City of Poulsbo

Subject: Pinnacle at Liberty Bay PRD and Preliminary Subdivision | P-06-20-25-03
Request for Revisions No. 4 and Updated Review Timeline

To: Montebanc Management LLC, John Everett
From: Donald Washburn, Engineering Technician
Subject: Pinnacle at Liberty Bay PRD and Preliminary Subdivision Submittal #4; P-06-20-25-03
Date: 7/2/2026

To: Montebanc Management LLC, John Everett
From: Josh Ranes, PE, City Engineer
Michael Bateman, PE, Transportation Engineer
Subject: Noncompliance with PMC 17.80.050 and 17.80.060 - Connectivity and multiple points of access/egress - Pinnacle at Liberty Bay PRD, P-06-20-25-03
Date: 6/15/2026

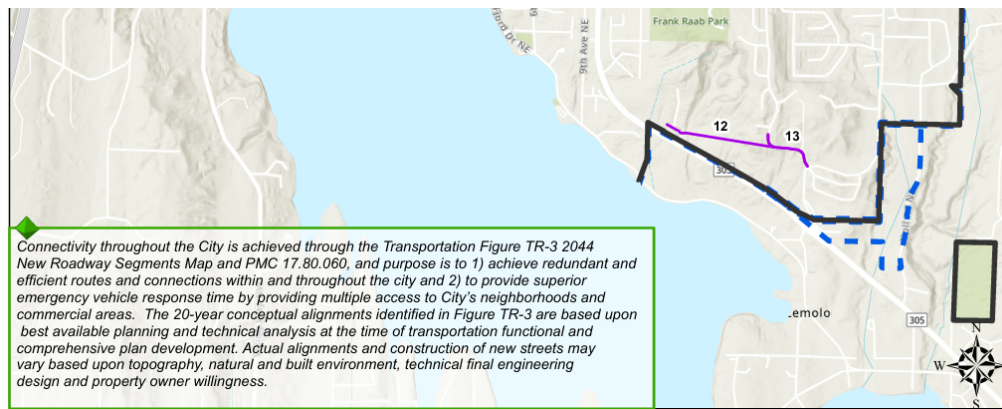
As proposed, the primary access to the project is provided by Sunrise Ridge Ave NE, a residential collector. The project includes 23 lots that will have direct access to Sunrise Ridge Ave NE. The remaining 115 lots are serviced by an internal looped road system that connects to Sunrise Ridge Ave NE at two locations approximately 330 feet apart.

Public safety and emergency response are fundamental considerations in the design of the City's transportation network and development projects. As currently designed, and absent the recommended conditions of approval, it is the determination of the City Engineer and staff that the project's proposed location, size and design do not provide the level of roadway redundancy and emergency access intended by the City's adopted codes, standards, and Comprehensive Plan to protect the public interest, health, safety, and welfare of the City. The site's topography, significant elevation changes, surrounding critical areas, and reliance on a single primary access corridor create a roadway network with limited redundancy and increase the potential for portions of the subdivision to become isolated should Sunrise Ridge Avenue NE become blocked or otherwise inaccessible.

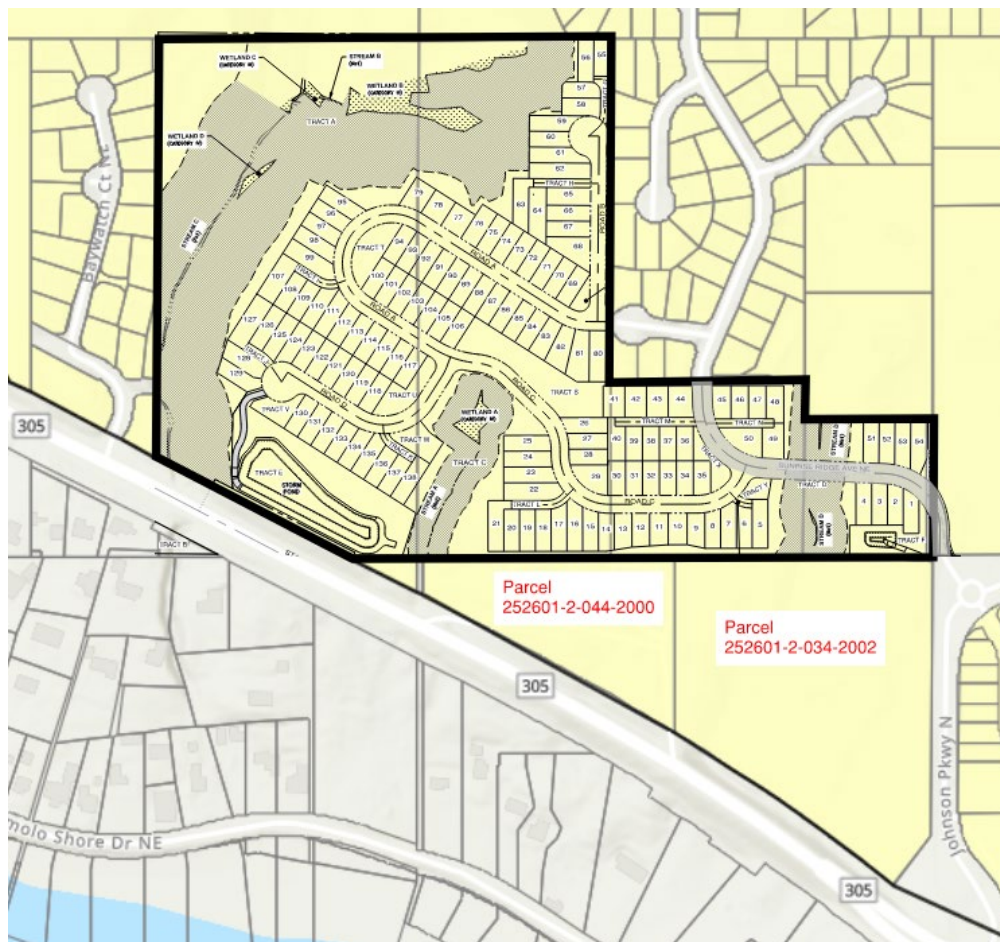
The Pinnacle at Liberty Bay provides two primary access points from Sunrise Ridge Ave NE serving the majority of homes in the subdivision. One access point (Road C) connects directly to the new NR-13 segment of Sunrise Ridge Avenue NE to be constructed as part of the project. The second access point connects to Sunrise Ridge Avenue NE via the planned extension of NE Crystallia Court within the existing Crystal View subdivision. Together, this internal looped roadway system provides primary access to 115 of the proposed 138 residential lots. The remaining 23 lots are served by two private access roads (Tracts M and N) and ten individual driveways with direct access to Sunrise Ridge Avenue NE. Although the subdivision includes two access points to Sunrise Ridge Avenue NE, both ultimately rely on the same public roadway corridor for ingress and egress from the development.

The two primary access points have an effective access distance along Sunrise Ridge Ave NE being approximately 330' apart. Tracts M and N access Sunrise Ridge Ave NE approximately halfway between the two primary access points. All of these connections access a single road – Sunrise Ridge Ave NE.

Providing the required new roadway segment NR-12 connecting to the existing Baywatch subdivision satisfies the City's adopted Future Roadway Segments Map, neighborhood connectivity requirements, and the

requirement for multiple redundant connections accessing different streets as required by PMC 17.80.050 and 17.80.060. This connection also satisfies International Fire Code (IFC) section 503.1.2 Additional Access where there is the potential for impairment of a single road by vehicle congestion, conditions of terrain, climactic conditions and other factors that could limit access, as well as IFC Appendix D D107.2 Remoteness requirements for distance between access points. Constructing this required roadway connection further mitigates the project's transportation impacts by avoiding the concentration of project traffic on a single roadway (Sunrise Ridge Avenue NE) and distributing trips across the surrounding street network, providing more direct westbound access to SR 305 for residents in the western portion of the development.
